STATE OF DELAWARE
EXECUTIVE DEPARTMENT
OFFICE OF MANAGEMENT AND BUDGET
STATE PLANNING COORDINATION

RE: PLUS review – PLUS 2006-09-10; North Georgetown RPC

Thank you for meeting with State agency planners on September 27, 2006 to discuss the proposed plans for the North Georgetown Residential Planned Community project to be located at Route 18, approximately 1,000 feet west of Route 113.

According to the information received, you are seeking a rezoning from AR-1 to MR/RPC for a planned community of 507 residential units and 113,700 sq. ft. of commercial space on 108 acres.

Map of North Georgetown (PLUS 2006-09-10) Excellent ground water recharge potential areas are highlighted in green. Wellhead protection areas are in red.

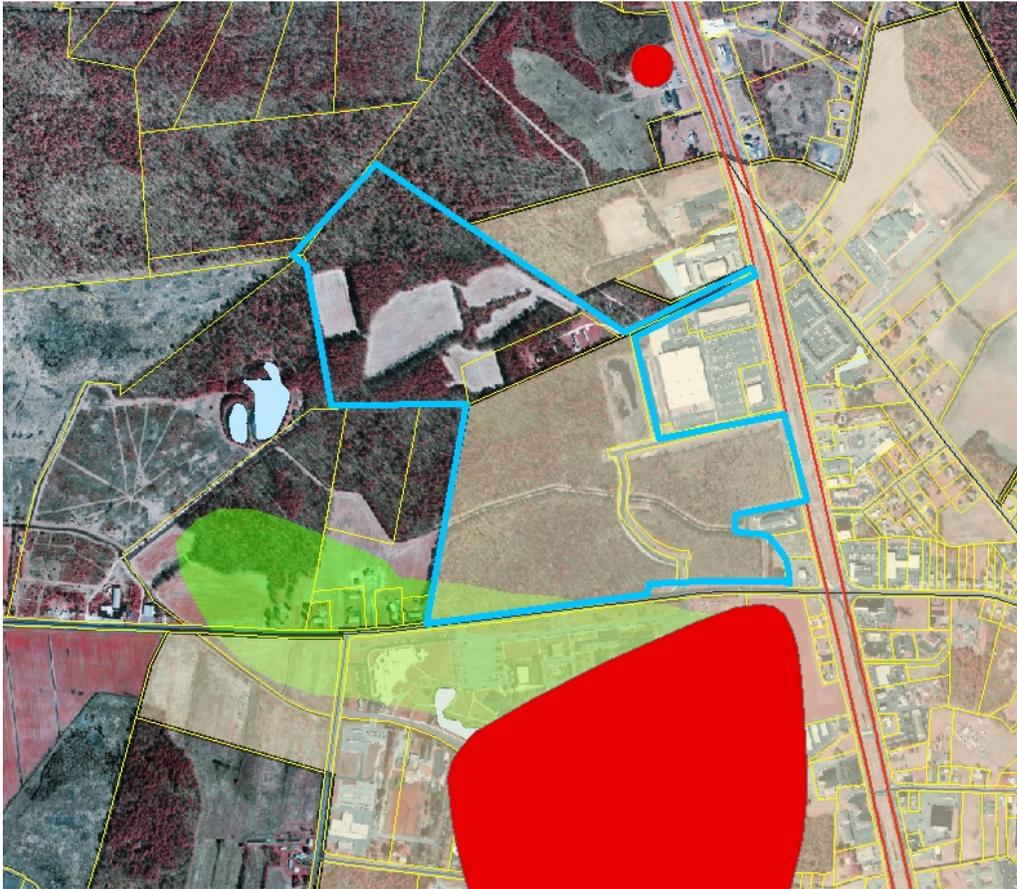
The Water Supply Section has determined that a small portion of the southwestern corner of the proposed development falls within an excellent ground water recharge area (see following map and attached map). The review found no wellhead protection areas.

Excellent recharge areas are near-surface areas within which precipitation infiltrates the land surface to the unconfined aquifer at a more rapid rate than other areas. This proposed development shows stormwater management ponds within the excellent ground water recharge area.

The Water Supply Section recommends that that portion of the new development within the excellent ground water recharge area not exceed 20% impervious cover. The purpose of an impervious cover threshold is to minimize loss of recharge (and associated increases in stormwater) and protect the quality and quantity of ground water and surface water supplies.
